Access Compliance Report

Public Rights-of-Way

(Curb Ramps)

Intersection ID: 12975	Main Street: HICKORY GROVE RD	Cross Street: HOBBS HILL DR	Location: SW
ADA ID: 83E28A7754FA	Ramp Type: PerpDiag	Initial Pass/Fail: Fail	Overall Compliance: No
Severity Score: 21.25			
Codes/Mitigation Info/Possible Solution		Field Measurements/Component Compliance

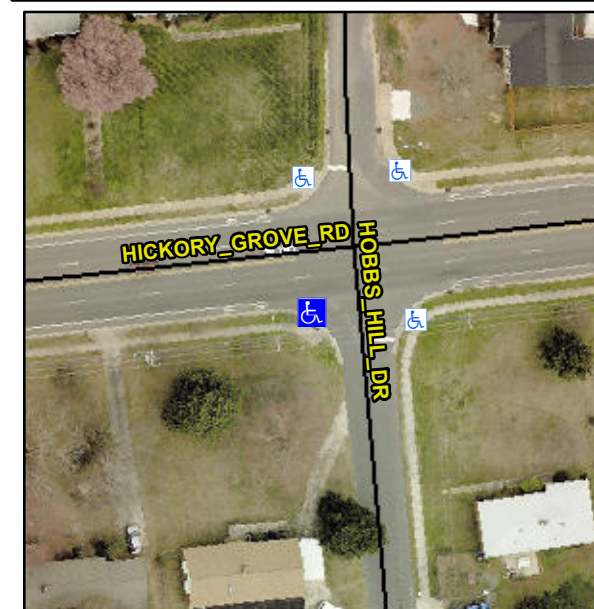
Not Found, R304.5.1, R304.2.2

Compliance	Description	Data	Compliance	Description	Data
N/A	Ramp Length (in)	48.0	No	Ramp Slope (%)	8.4
No	Ramp Width (in)	41.5	Yes	Ramp XSlope (%)	0.2
N/A	Flare Type LT	N/A	N/A	Flare Type RT	N/A
N/A	Flare Slope LT (%)	N/A	N/A	Flare Slope RT (%)	N/A
N/A	Flare Traversable LT?	N/A	N/A	Flare Traversable RT?	N/A
N/A	Landing Length (in)	N/A	N/A	DWS Provided?	N/A
N/A	Landing Width (in)	N/A	N/A	DWS Contrast?	N/A
N/A	Landing Slope (%)	N/A	N/A	DWS Length (in)	N/A
N/A	Landing X Slope (%)	N/A	N/A	DWS Full Width?	N/A
N/A	Landing Curb? (Y/N)	N/A	N/A	DWS Offset (in)	N/A
N/A	Shared Landing?	N/A			
N/A	Gutter Ponding?	N/A	N/A	Gutter Slope (%)	N/A
N/A	Gutter Lip Ht (in)	N/A	N/A	Gutter X Slope (%)	N/A
N/A	Painted X Walk1?	No	N/A	Painted X Walk2?	No
	X Walk 1 Direction	To E		X Walk 2 Direction	To N
N/A	X Walk 1 Width (in)	N/A	N/A	X Walk 2 Width (in)	N/A
	X Walk 1 Slope (%)	4.0		X Walk 2 Slope (%)	1.0
	X Walk 1 X Slope (%)	1.8		X Walk 2 X Slope (%)	2.2

Remove & Replace Curb Ramp With Two New Directional Ramps or Equivalent.
